Re: Red Dome In.'s pending mining plan proposal

Enclosed please find a revision map and substitute paragraphs for the previously submitted and pending mining plan proposal we have been working on. The map was developed by civil engineer Lynn Wall, for Red Dome Inc., after he consulted with Doug Jensen of your office. The map and substitute paragraphs should answer the request sent by Susan White according to our understanding at the meeting in your office September 8. Please consider this revised map and designations as substitutes for all previously submitted maps and designations of areas to be mined and reclaimed.

SITE PLAN

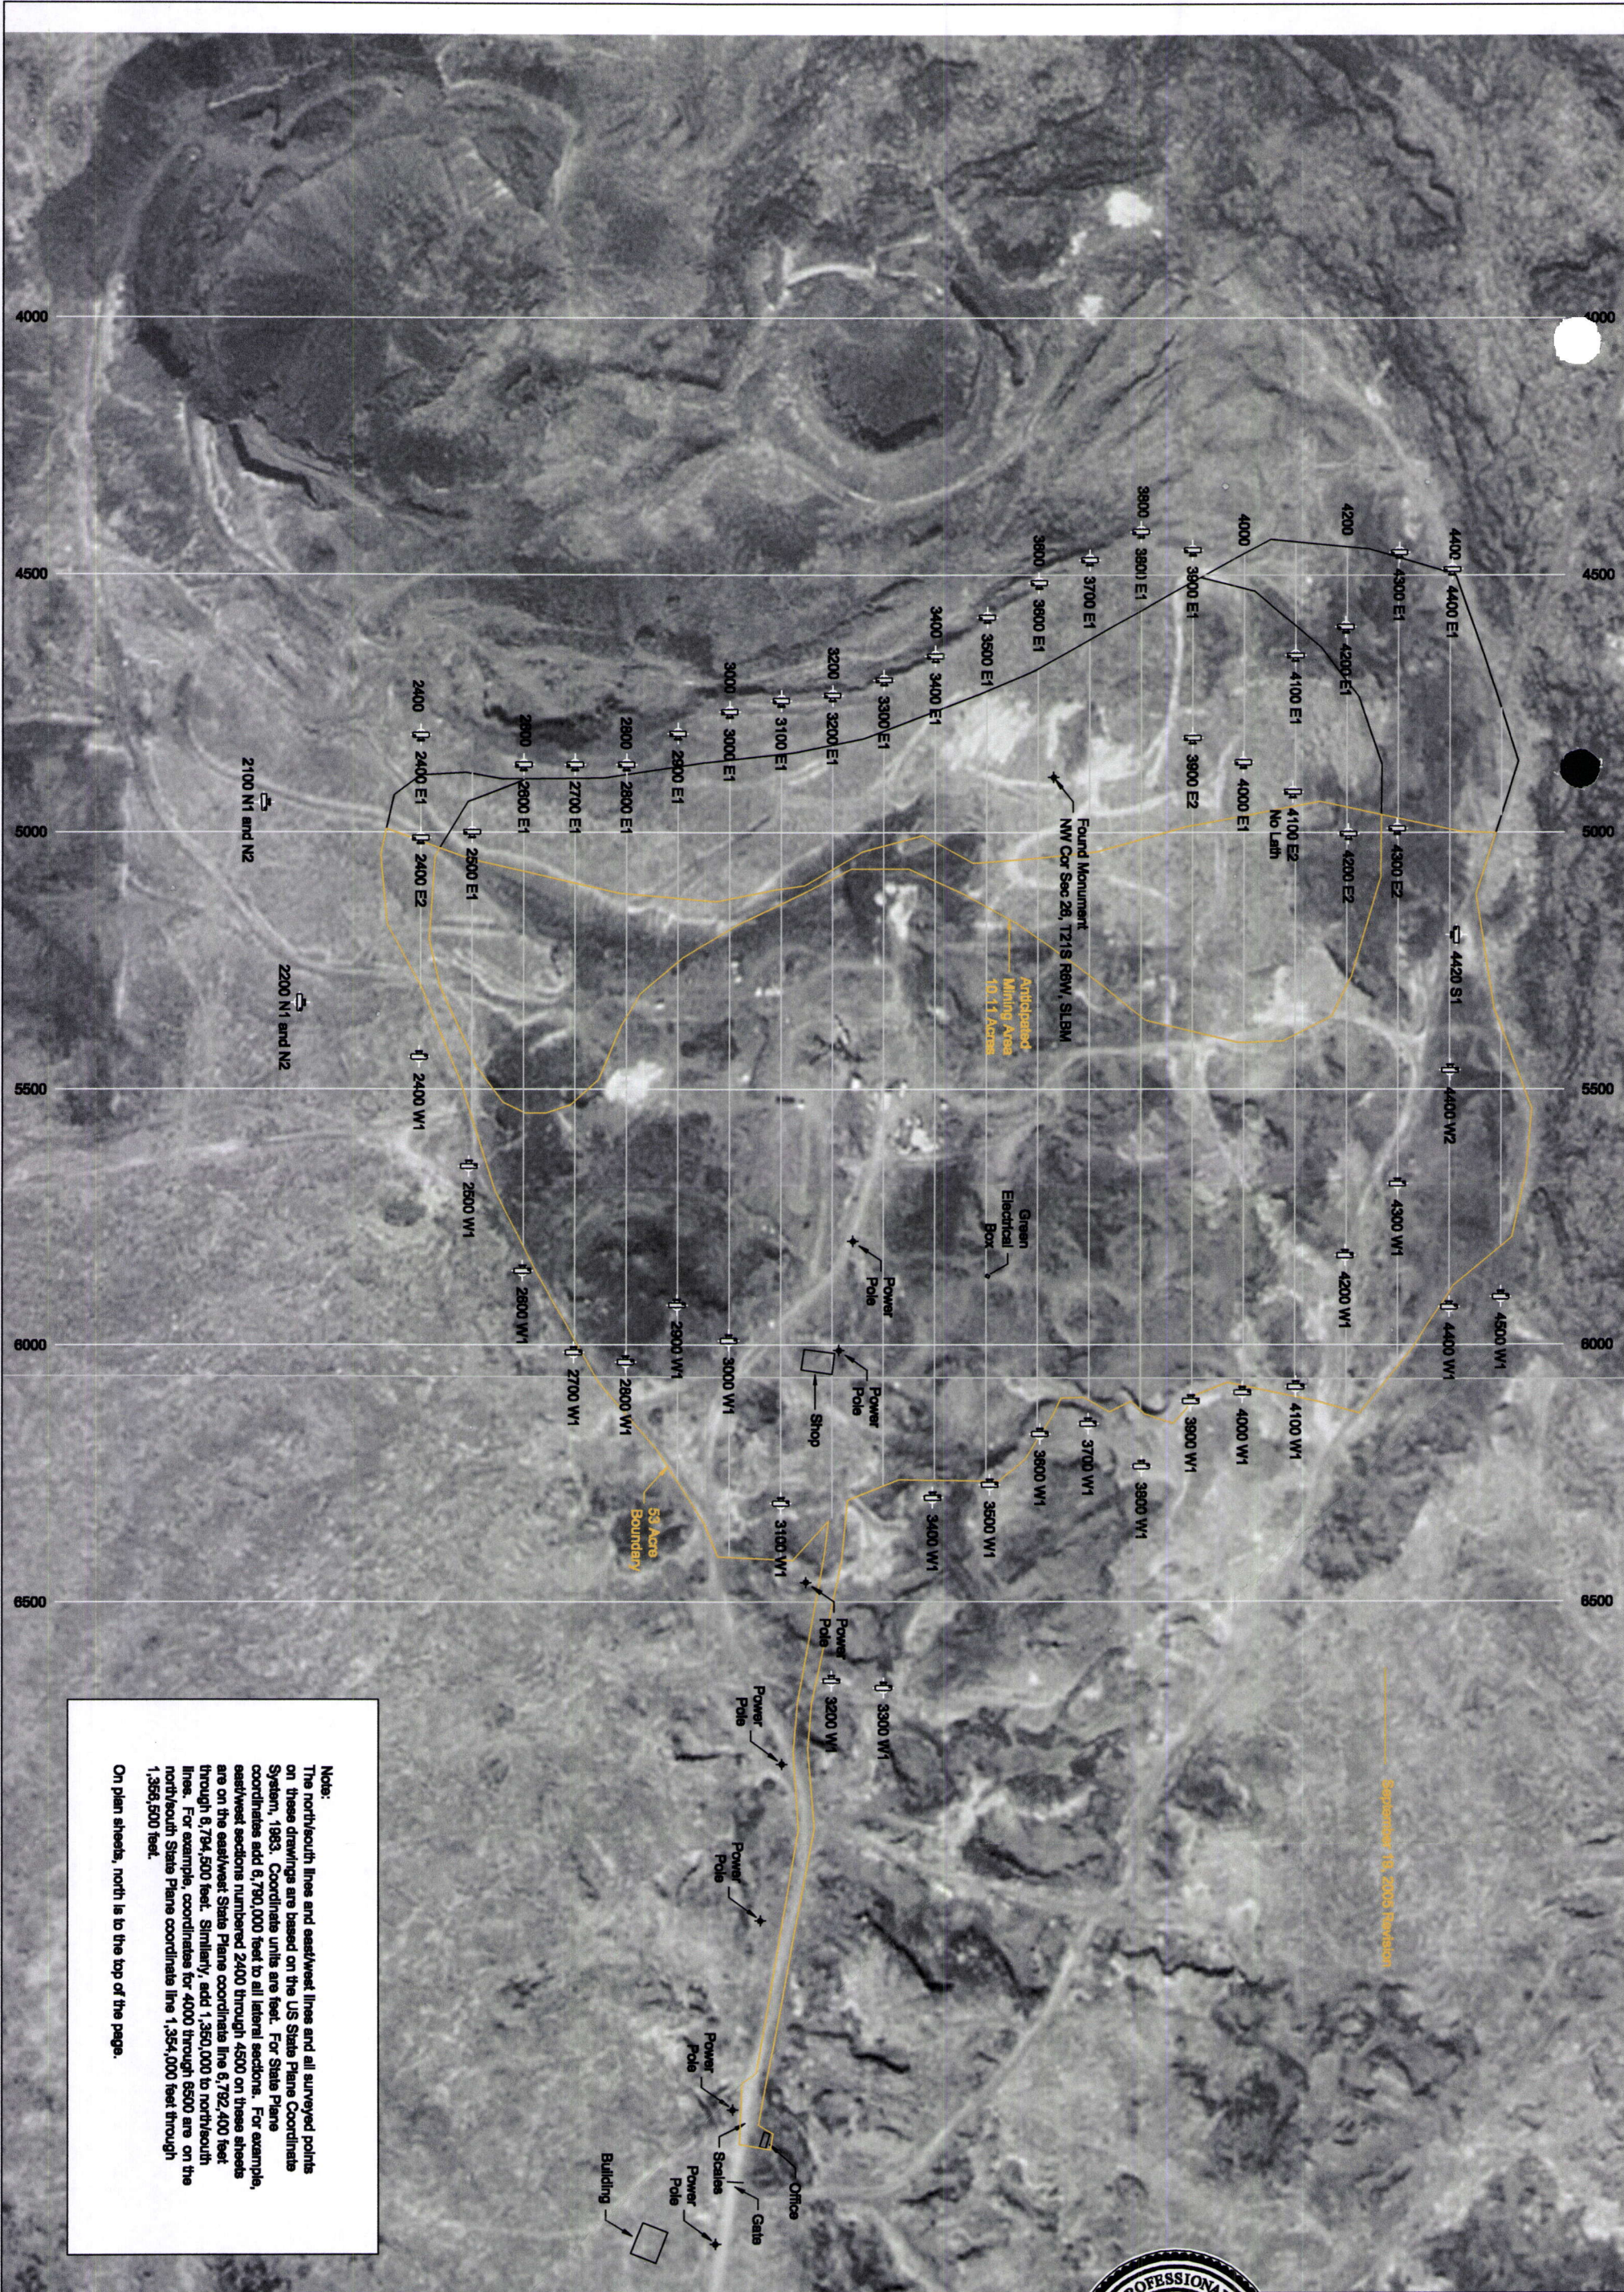
*Red Dome Incorporated site plan plat revised September 19, 2005 shows within the yellow lines the disturbed area for the updated mining plan. Also included are the office, scale and roads utilized for mining purposes. The office is a non-permanent structure, the scales are easily removed. The telephone buried lines belong to Frontier Communications (800-921-8104) and are not the property of Red Dome Inc. The power poles and the power lines belong to Flowell Electric Assn., located in Flowell Utah. (435-743-6214)*
